TENNESSEE VALLEY AUTHORITY

In section 5.3.2 of Supplement 1 to the Sequoyah Nuclear Plant (SQN) Safety Evaluation Report (SER), NRC identified actions associated with the Residual Heat Removal (RHR) low-flow alarm, to be completed before startup after the first refueling outage for each unit. As required by the NRC, we have completed the installation of the RHR low-flow alarm, and have enclosed our response to the action items.

### Response to NRC Requirements In Sequoyah Nuclear Plant SER, Section 5.3.2

#### RHR Low-Flow Alarm

Figure 1

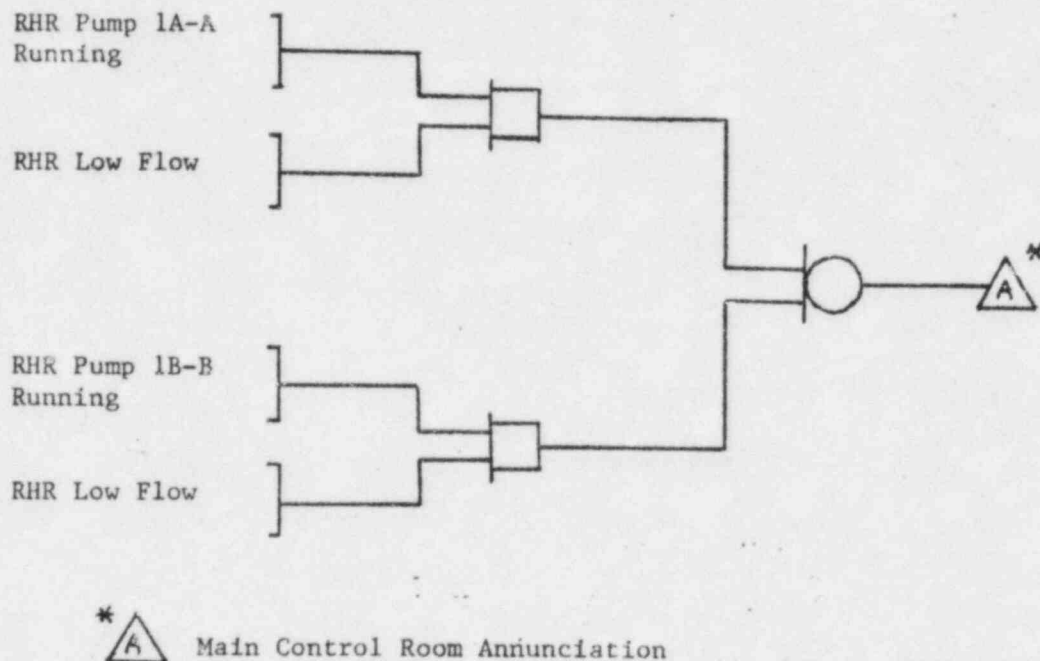
In section 5.3.2 of the Safety Evaluation Report (SER), NRC's staff required the installation of a low-flow alarm on the RHR system. Concern was expressed about spurious isolation of the RHR system. Also stated in the SER was the need for further confirmatory documentation of the capability of the RHR system to meet the Branch Technical Position RSB 5-1, "Design Requirements of the Residual Heat Removal Systems." In Supplement 1 of the SER, the following actions were required before startup after the first refueling outage.

1. The applicant to provide a detailed description of the sensors which activate the alarm
2. Installation of the alarm
3. The applicant to provide test procedures which will be used to verify alarm functional adequacy
4. The applicant to identify settings for alarm sensors
5. The applicant to provide results from the tests demonstrating the functional adequacy of the alarm system
6. NRC staff review and approval of items 1 through 5

1. The sensors which activate the RHR low-flow alarm system consist of Barton model 224 differential pressure units (DPUs) and Barton model 228A differential pressure indicating switches. The function of the DPU is to sense the differential pressure developed across an orifice plate, one of which is located on the high-pressure side of each RHR pump. The 228A switch closes an alarm circuit contact when the flow falls below the setpoint.

2. Installation of the RHR low-flow alarm system was completed September 1980. Figure 1 is a logic diagram of the alarm system.
